ANDREWS 115 kV SUB-STATION - UPGRADE

IESO EXPEDITED SYSTEM IMPACT ASSESSMENT – CAA ID 2005-EX248

EXPEDITED SYSTEM IMPACT ASSESSMENT REPORT – CAA ID 2005-EX248

FIGURE 1B : PROPOSED ARRANGEMENT IN ANDREWS GS

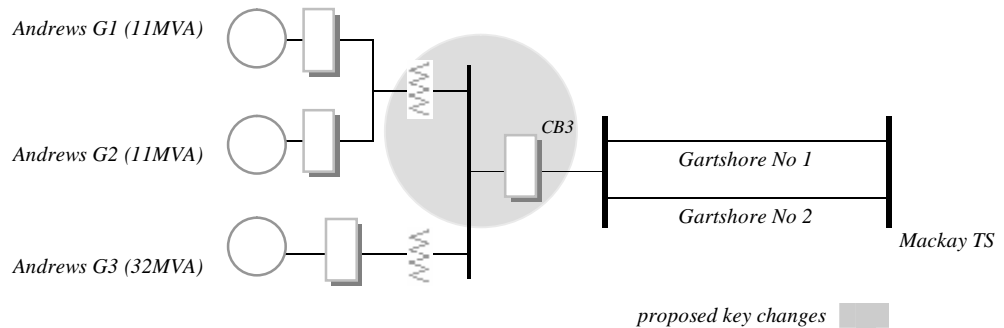
Currently, each of the generators has its own step-up transformer. The owner of the station, Brascan Power Corporation has informed the IESO that they will replace the existing step-up transformers of G1 and G2 with a new single step-up transformer and the two oil circuit breakers CB1 and CB2 with a new SF6 breaker CB3 as shown in Figure 1B.

The 12 kV and 115 kV disconnect switches located on either side of the step-up transformers will also be replaced with new air break switches. In addition, a new transformer protection will be installed and the revenue meter will be relocated between the common 115 kV bus and the new circuit breaker CB3.

According to the data available to the IESO, the equivalent impedance of the two existing step-up transformers for G1 and G2 is $0.0405 + j0.4872$ pu on 100 MVA base. On the same base, the impedance of the new single step-up transformer is $0.0138 + j0.4047$ pu. Although the new step-up transformer appears to have a lower impedance than the existing equivalent, while this is better for the stability and for the voltage control, this change would slightly increase the line-ground fault level in the area. However, the increase is considered to be immaterial.

The Market Rules also require that for northern Ontario, the equipment with 115 kV nominal rating must have the capability to continuously operate at 132 kV. The proponent must confirm whether the 115 kV winding and the accessories of the new transformer comply with such a standard.

While the interrupting time of the new breaker complies with the code, the rated symmetrical short circuit level of the proposed breaker is only 40 kA. If future system modification will result in an increase of the short circuit levels in the area beyond 40 kA, the proponent will be required to replace the breaker with a higher rated unit.

Presently, the three step-up transformers in Andrews GS are accompanied by two 115 kV breakers. Thus, for a transformer fault, only a part of the generation would be lost. However, with the proposed arrangement, there would be only a single 115 kV breaker and this would increase the exposure for loss of entire generating station for a fault at a transformer or any local 115 kV busbar. Since, traditionally the fault incident rate for transformers and buses has been very low, the proposed installation of the new transformer is not expected to have any material impact on the reliability of the IESO-controlled grid.

ROTOR ANGLE OF ANDREWS G1 OR G2

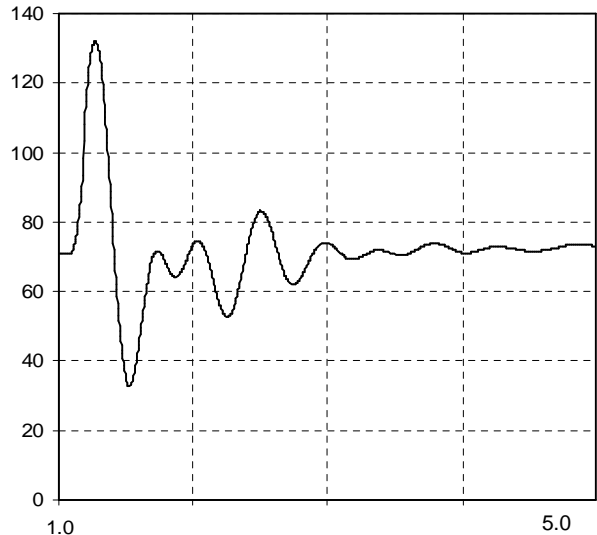
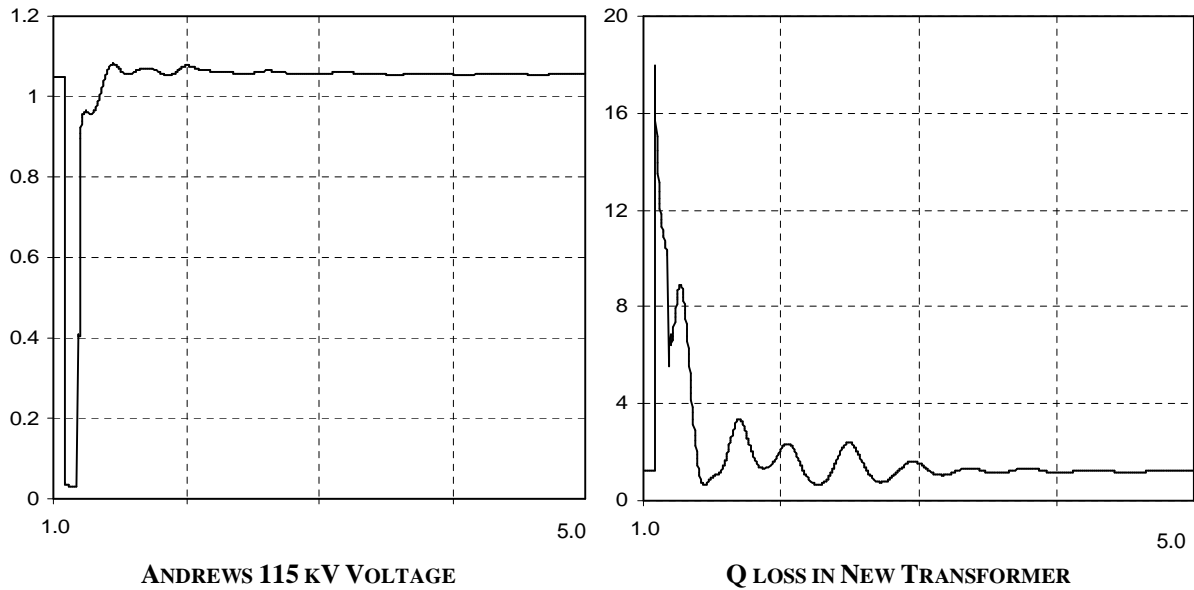
The projected variations in Andrews G1 (or G2) rotor angle, Andrews G1+G2 reactive power output, Andrews 115 kV voltage and the reactive loss occurring in the new transformer are shown below.

The results of the transient stability studies show that the post-fault transients of the rotors appear to be sufficiently damped. Therefore, the impedance of the proposed transformer does not seem to have any detrimental effect on the stability of the generators.

Further, the initial transient surges/drops are expected to be shorter than shown above for line-to-ground faults that are normally used to test the performance of generators in northwest region of the IESO-controlled grid.
